Lot 121 DC - 155 Duncan Creek Rd., Lillington, NC 27546

**PLAN 1
The Clayton - LH**

**'LOW COUNTRY'
ELEVATION**

11-27-23 - Initial Redlines

OPT. FIREPLACE @ COVERED PATIO/PORCH

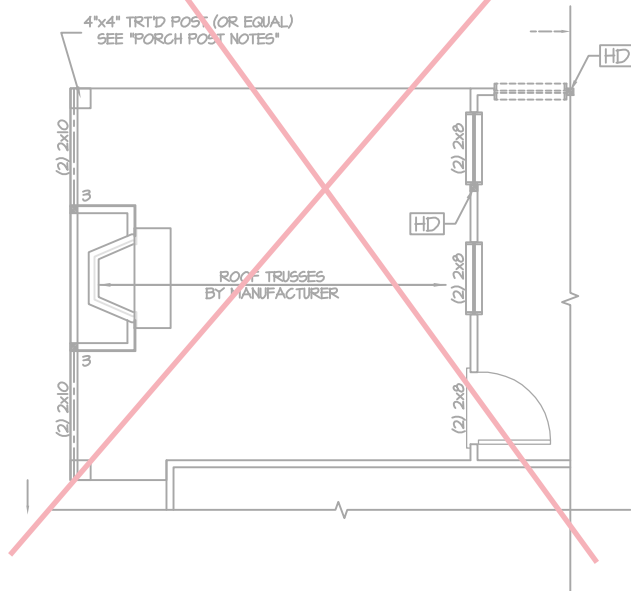
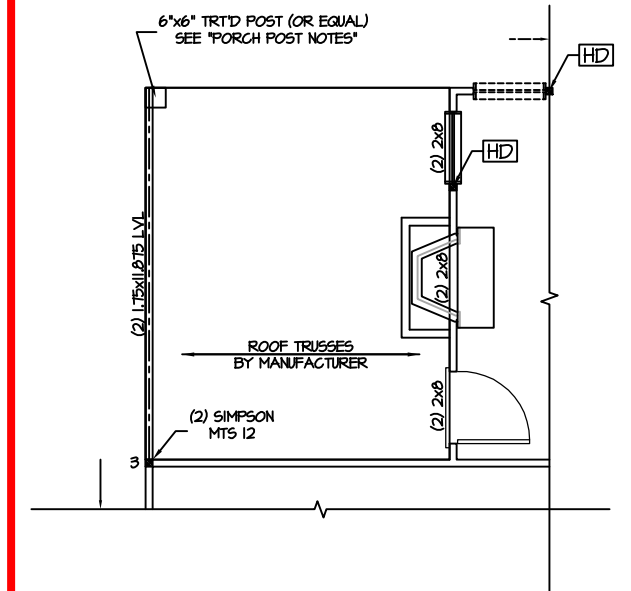
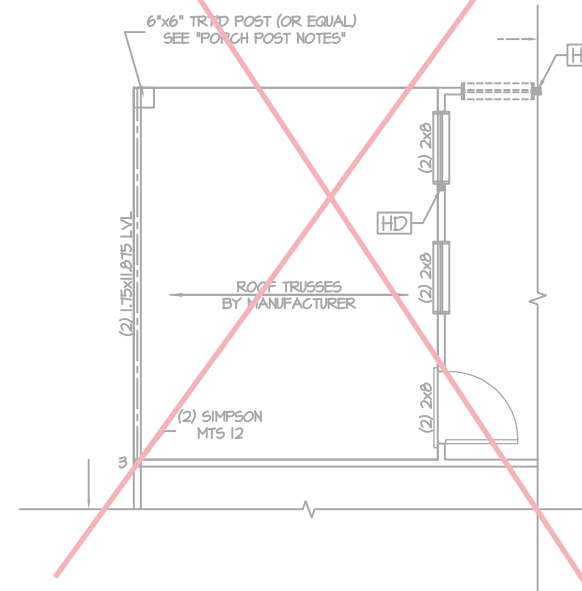
~~OPT. FIREPLACE @ EXT COVERED PATIO/PORCH~~

~~OPT. COVERED PATIO OR COVERED PORCH~~
